DATE : 12.10.14	JOB # : 1186 QA1346-28
RE: <b>30 Westland Avenue, Milford, CT</b>	
(CDBG-DR) & (OORR) Programs	
ADDENDUM #1

**Community Development Block Grant Disaster Recovery Program (CDBG-DR)  
Owner Occupied Rehabilitation and Rebuilding Program (OORR)**

**30 WESTLAND AVENUE, FAIRFIELD, CT**

**Addendum # 01  
December 10, 2014**

**SK S-3**

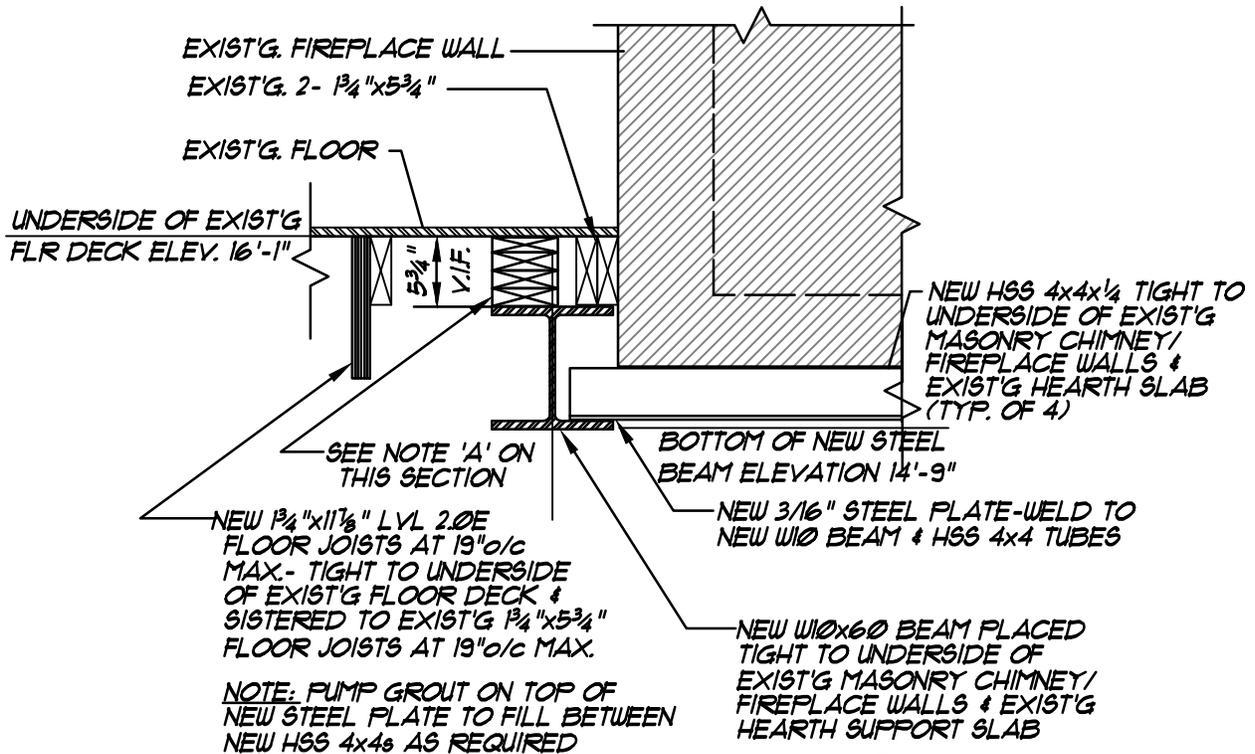
1. Clarification regarding the regarding the design for supporting the existing fireplace assembly: See the attached SKS2 & SKS3 – indicating redesign of the steel support system. The owner is aware that there may need to take portions of the fireplace apart (from the inside) to accommodate unforeseen conditions.
2. Q: What is the scope of electrical work that is being done within the house?  
A: There is none. Just the service to the house.
3. Clarification regarding the electrical service meter: The meter will be raised, but will remain on its current wall. The proposed location of the HVAC condenser unit is to be located just outside of the bathroom (on the deck).
4. Clarification: The plans call for putting the utilities underground. Provide cost to replace driveway due to excavation for this work.
5. Clarification: Alternate One is a Deduct Alternate.

NOTE 'A': NEW CONT. 2x6 12 ANCHORED TO NEW STEEL BEAM W/ 3/8" φ THRU-BOLTS AT 24" o/c MAX. PROVIDE MULTIPLE 2x 12s TO INFILL TIGHT TO UNDERSIDE OF EXIST'G FLOOR DECK NAIL AS REQUIRED.
